Rezoning Transportation Analysis

Petition Number: #2022-161

Date	Description
02-23-23	First Review (PDM)
04-20-23	Second Review (PDM)

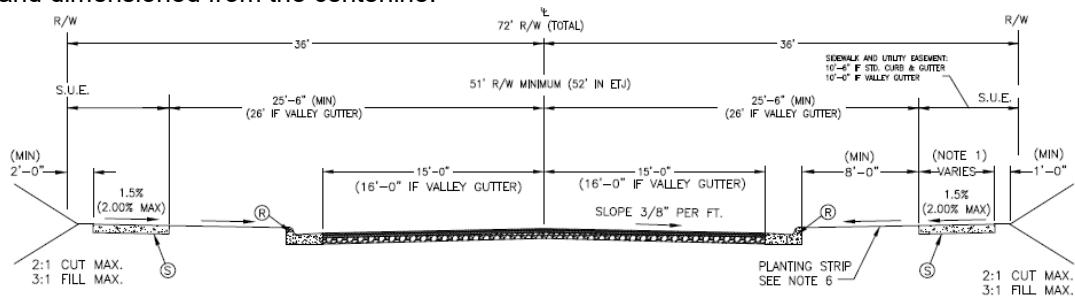
- a. ~~**Steele Creek Road:** Location of the future curb and gutter to be installed at 33 feet from roadway centerline to accommodate the Charlotte Streets Map roadway typical section of four plus lane avenue with shared use path. The future curb and gutter should be shown on the plan and dimensioned from the centerline.~~

- b. ~~**Parkside Crossing:** Location of the future curb and gutter to be installed at 17.5 feet from roadway centerline to accommodate the Charlotte Streets Map roadway typical section of collector street per CLDSM U-07. The future curb and gutter should be shown on the plan and dimensioned from the centerline.~~

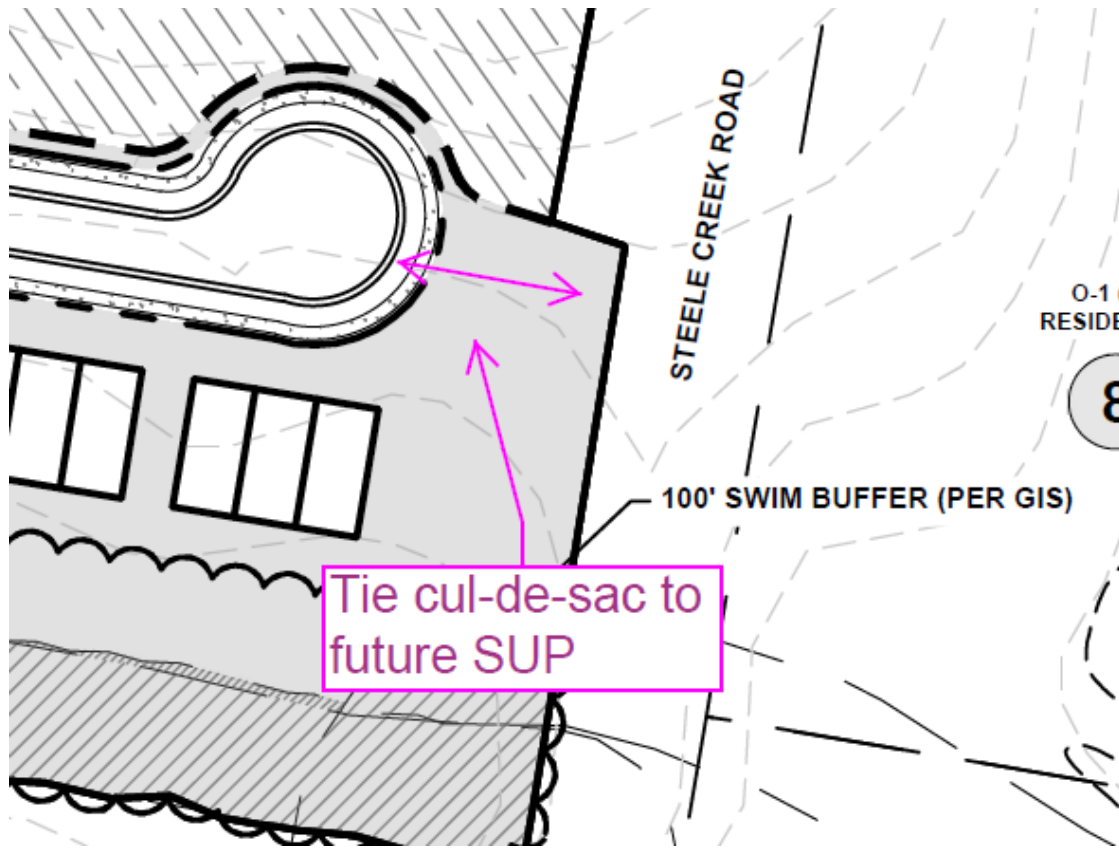
- ~~4. Revise site plan and conditional note(s) to show the previously approved sidewalk and the curb and gutter along Parkside Crossing.~~

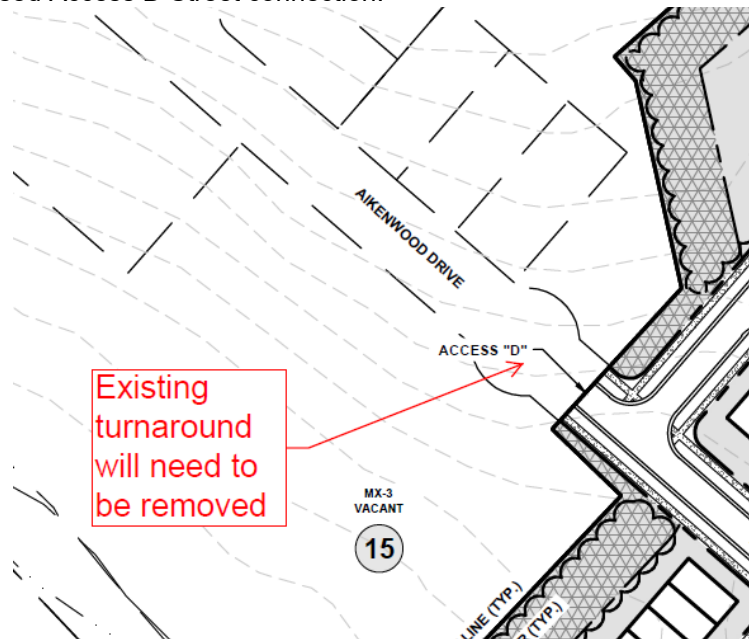
7. Revise site plan and conditional notes to commit to removing the existing turnaround on Aikenwood Drive at the proposed Access D Street connection.

Update to Comment 4.20.2023: Show proposed road extension tying into Access A.
